Architect's Supplemental Instructions

Architect's ASI No: 035

Project:
Webster University
Interdisciplinary Science
Building

Discipline Code: 03 Electrical

**LEVEL 01 FLOOR PLAN -
AREA B**

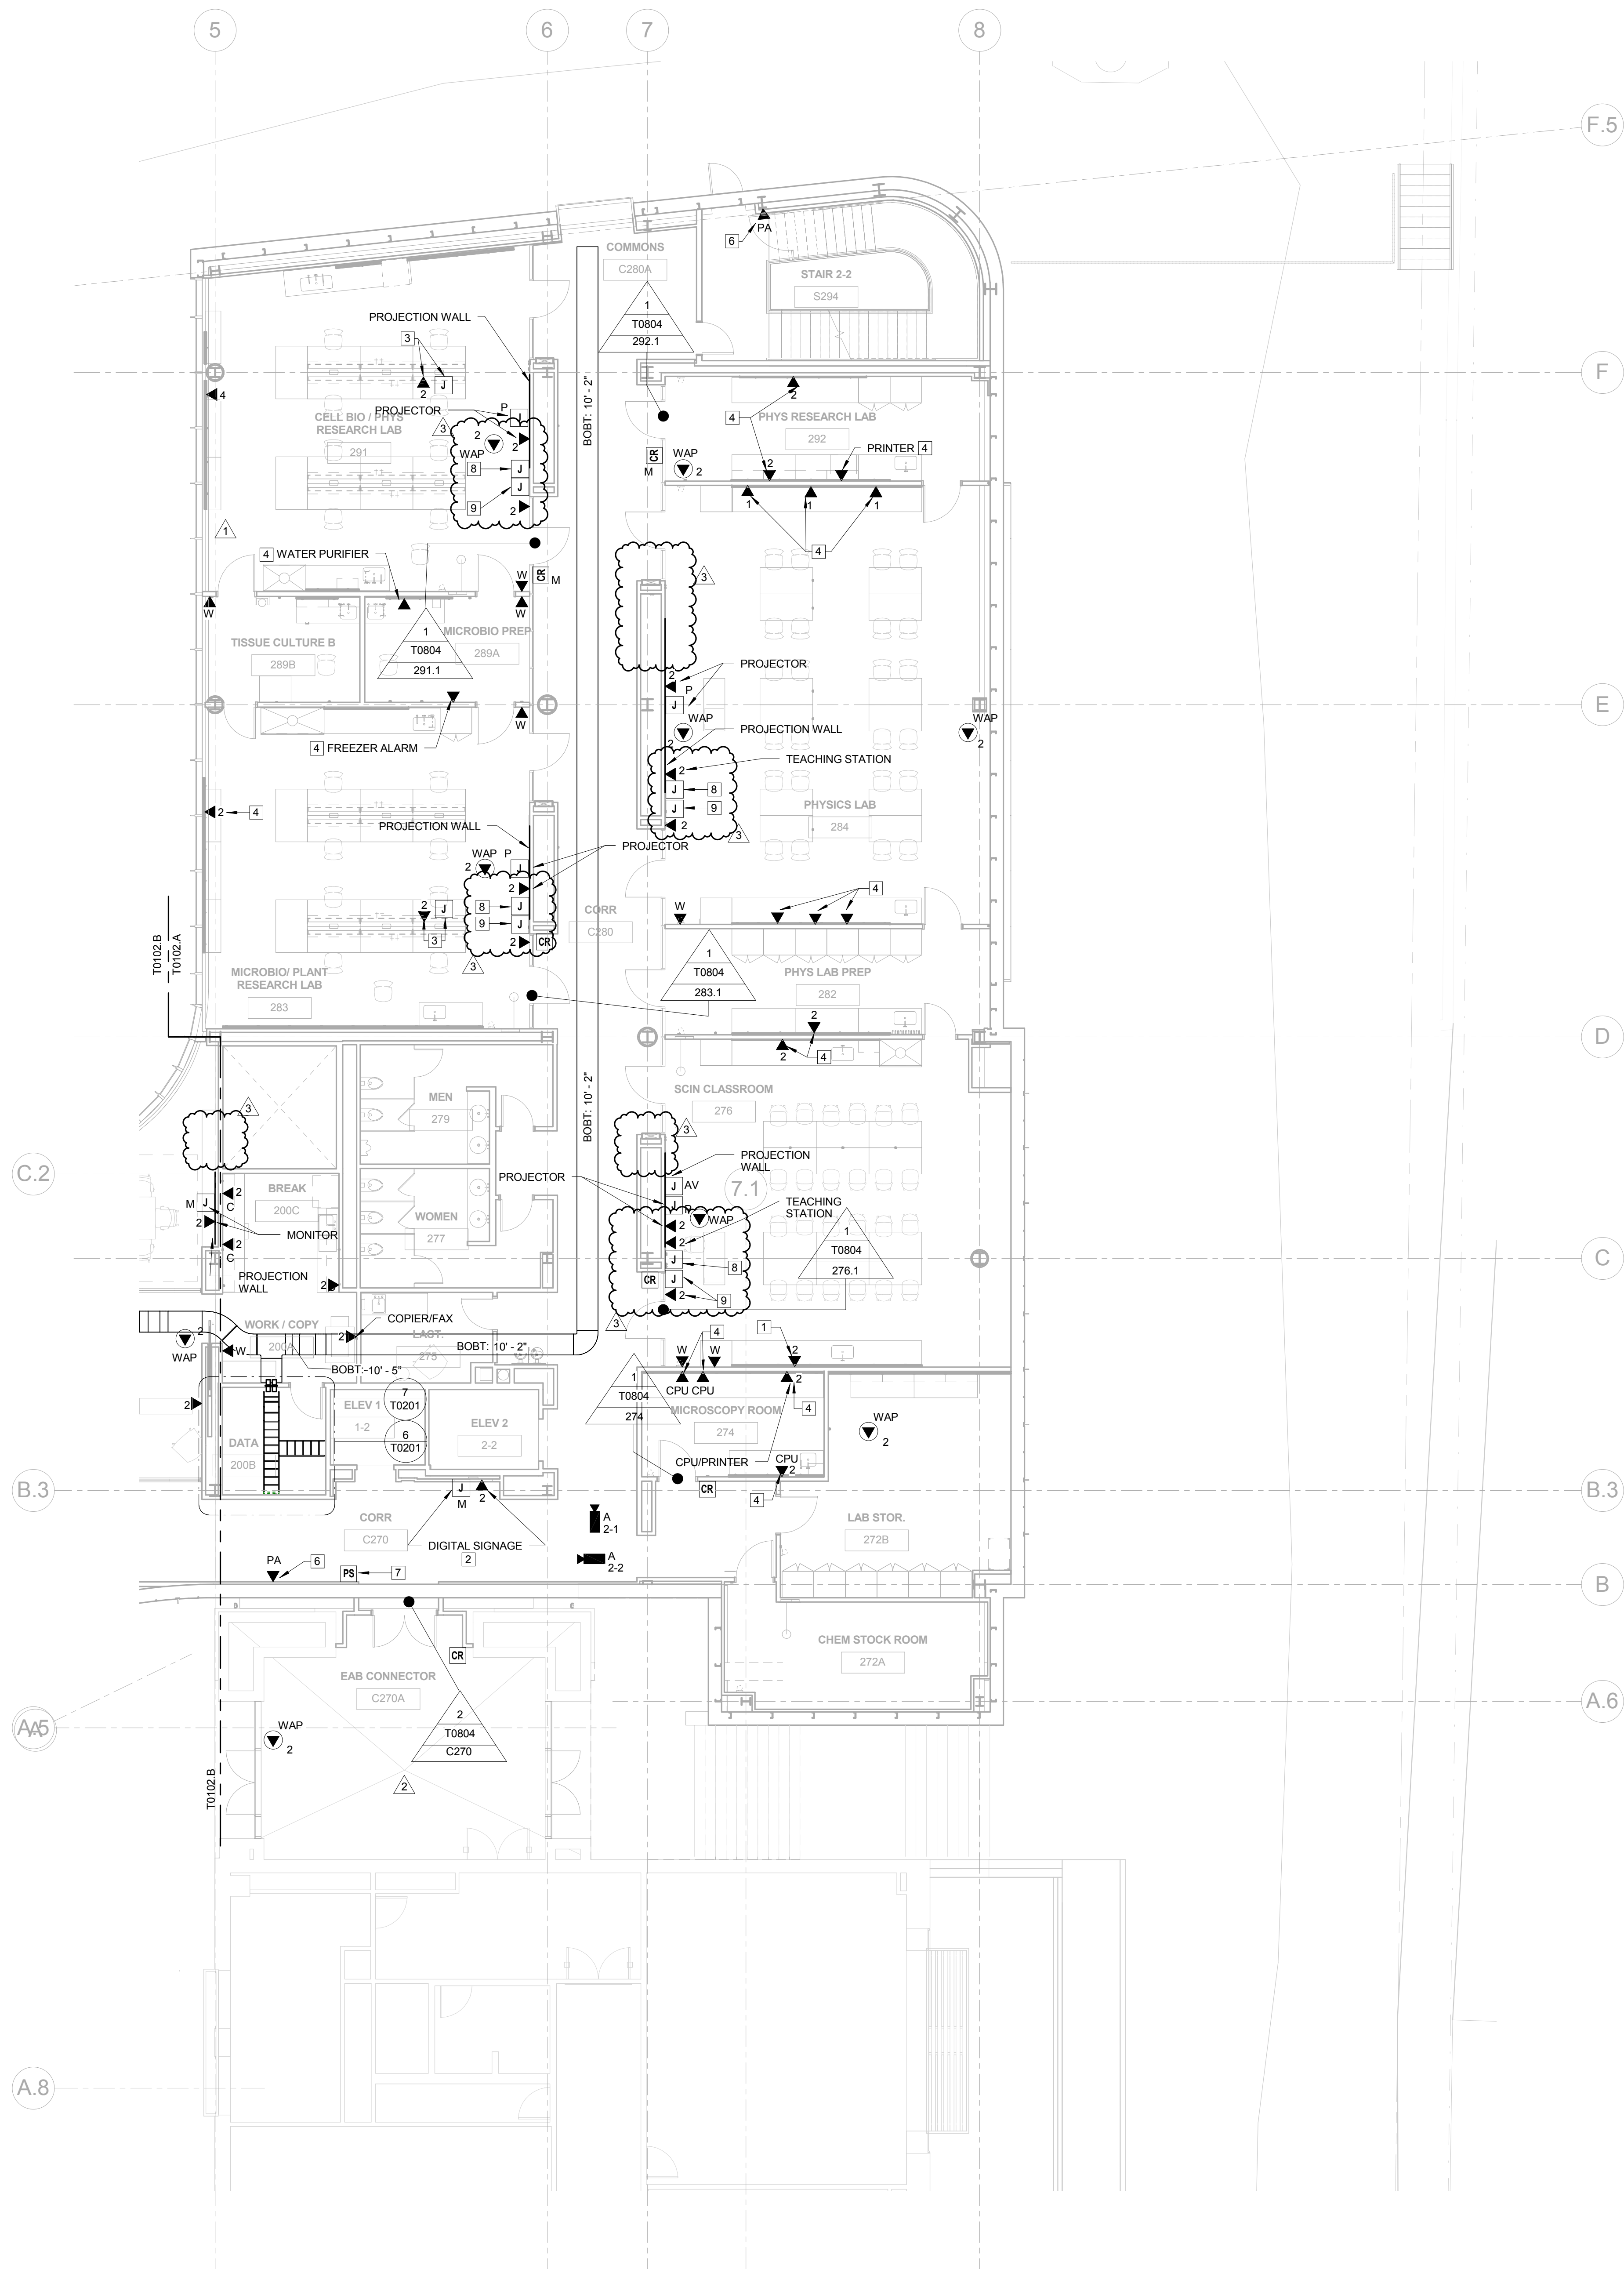
1. T0001 – SYMBOLS AND ABBREVIATIONS
 - A. Revised symbol description.
2. T0101.A – LEVEL 01 FLOOR PLAN – AREA A
 - A. Revised AV infrastructure in several locations.
3. T0101.B – LEVEL 01 FLOOR PLAN – AREA B
 - A. Revised AV infrastructure in several locations.
4. T0102.A – LEVEL 02 FLOOR PLAN – AREA A
 - A. Revised AV infrastructure in several locations.
5. T0102.B – LEVEL 02 FLOOR PLAN – AREA B
 - A. Revised Keyed Note.
6. T0103.A – LEVEL 03 FLOOR PLAN – AREA A
 - A. Revised AV infrastructure in several locations.
7. T0104.A – LEVEL 04 FLOOR PLAN – AREA A
 - A. Revised AV infrastructure in several locations.

A0101.B

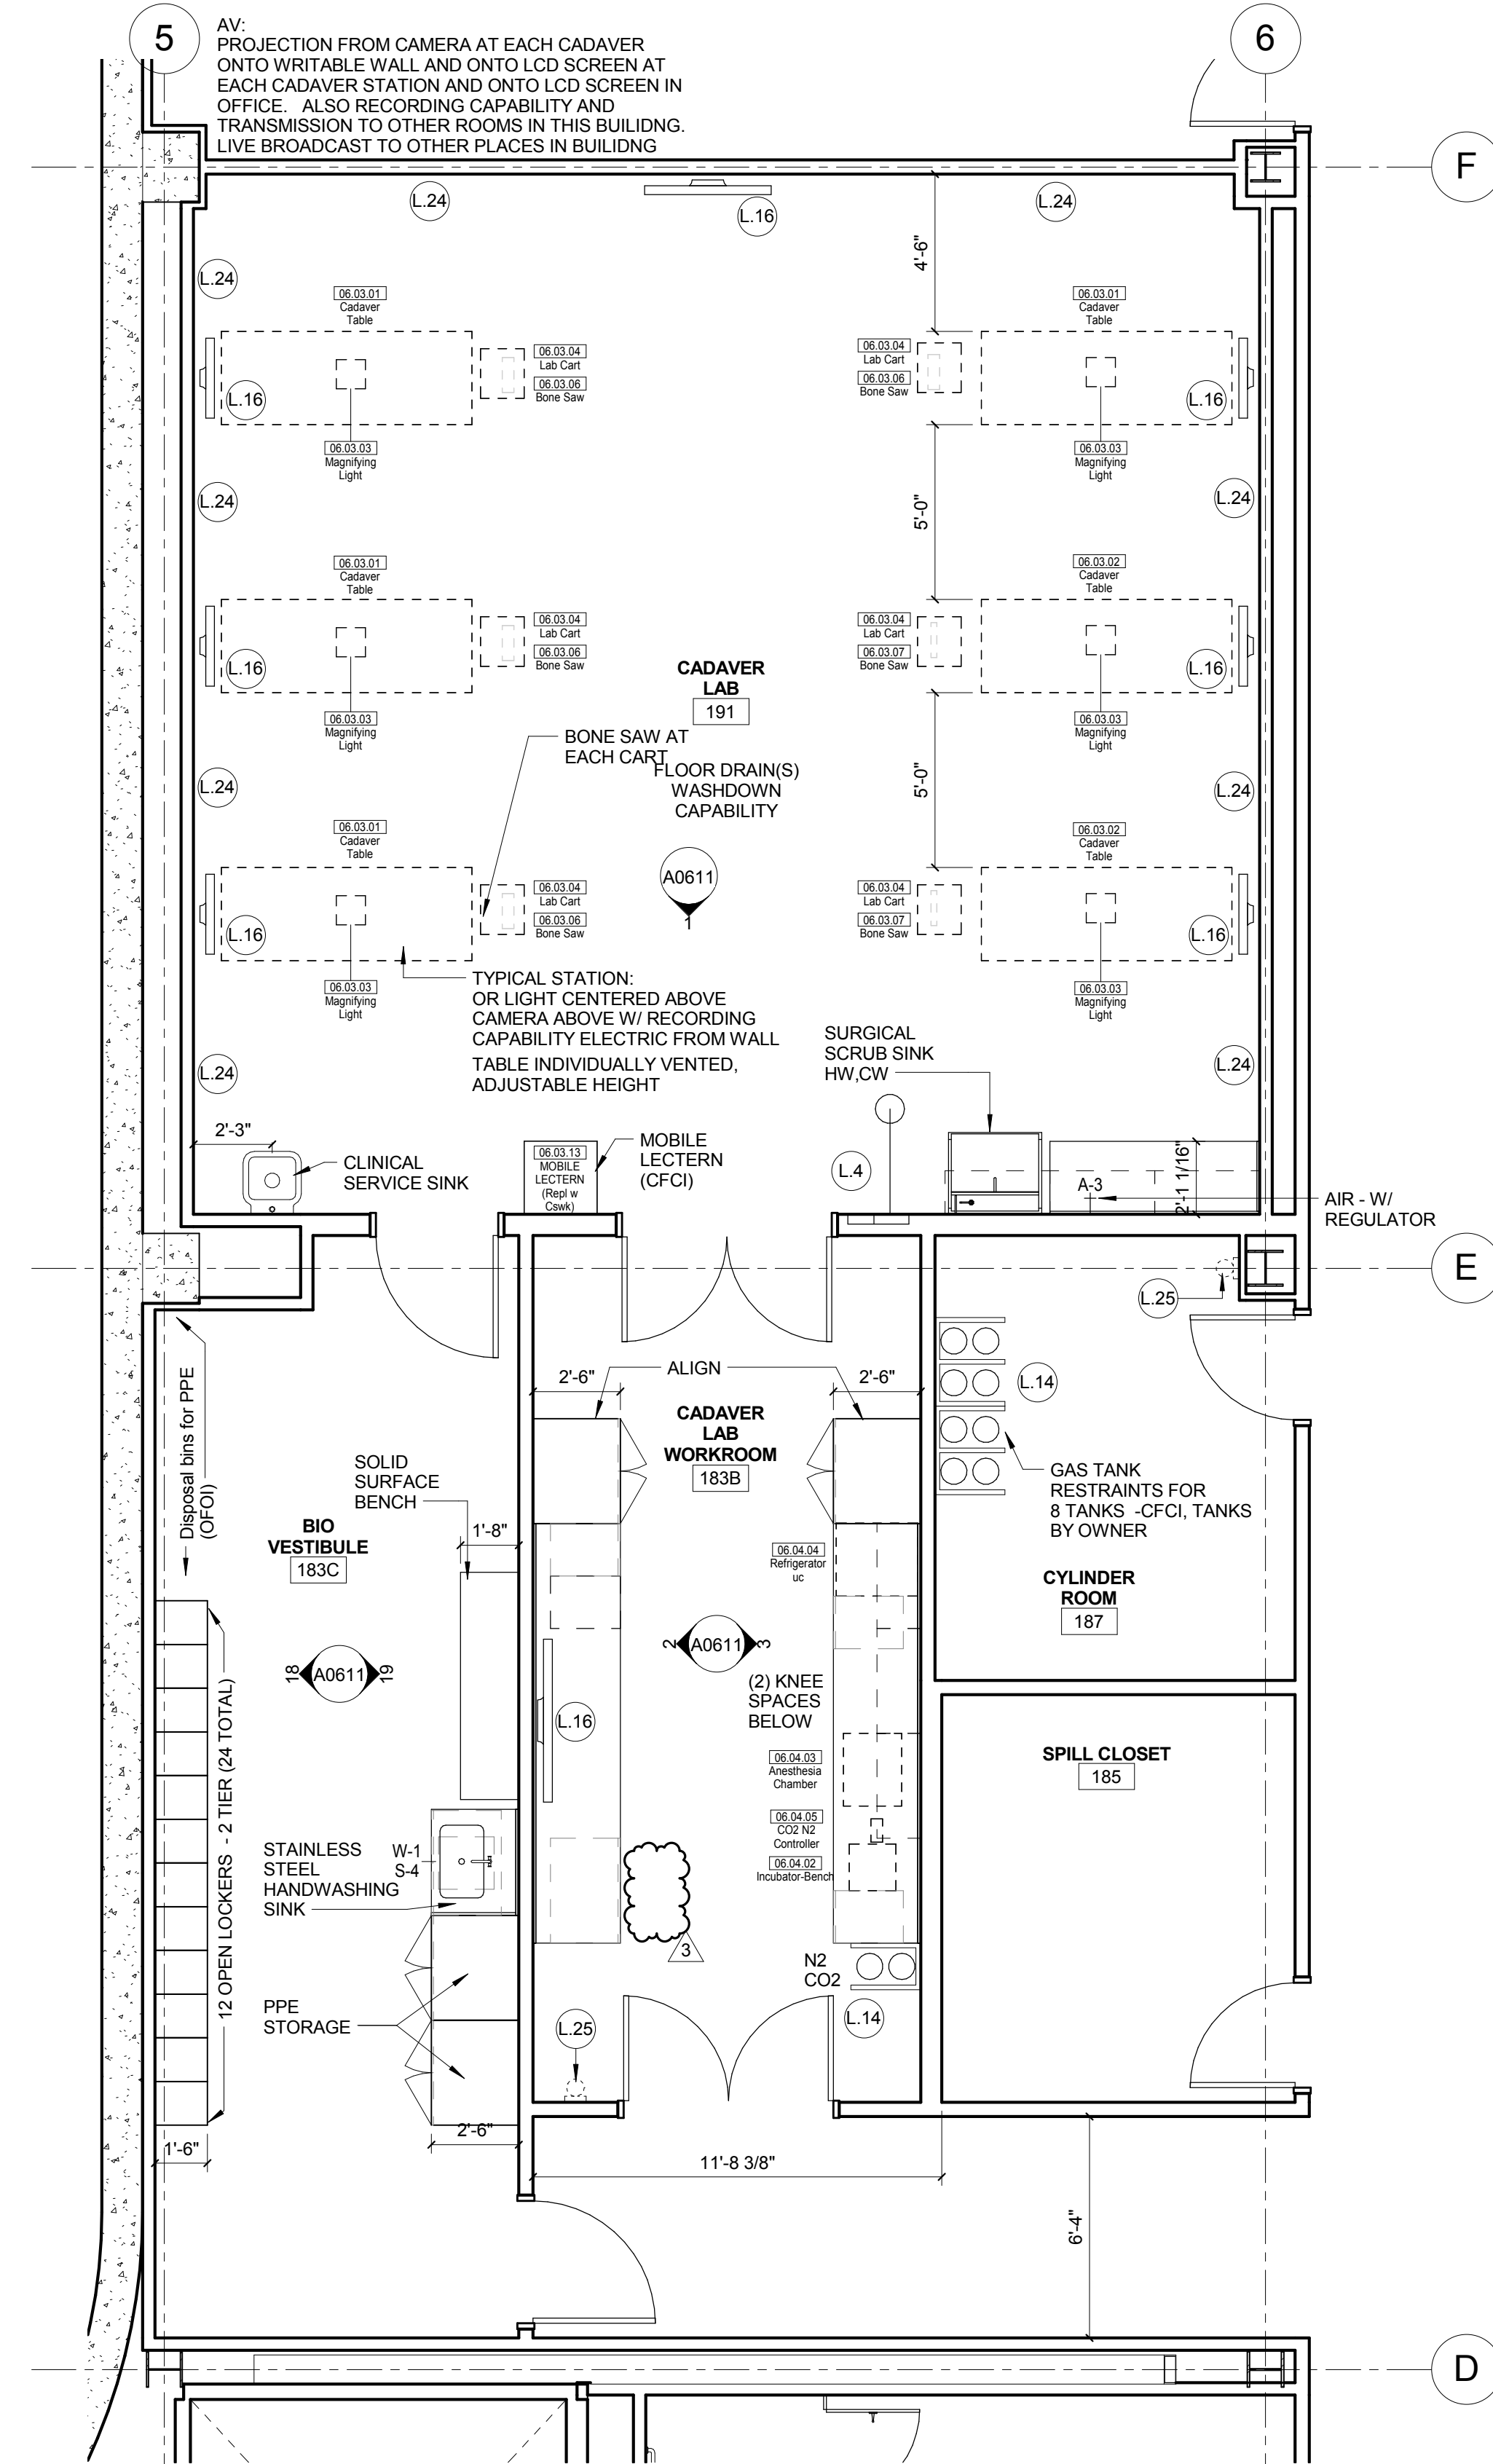
A0101.B, A0201, A0601, A0611, A0901, A0912:
Casework revisions based on AV package.
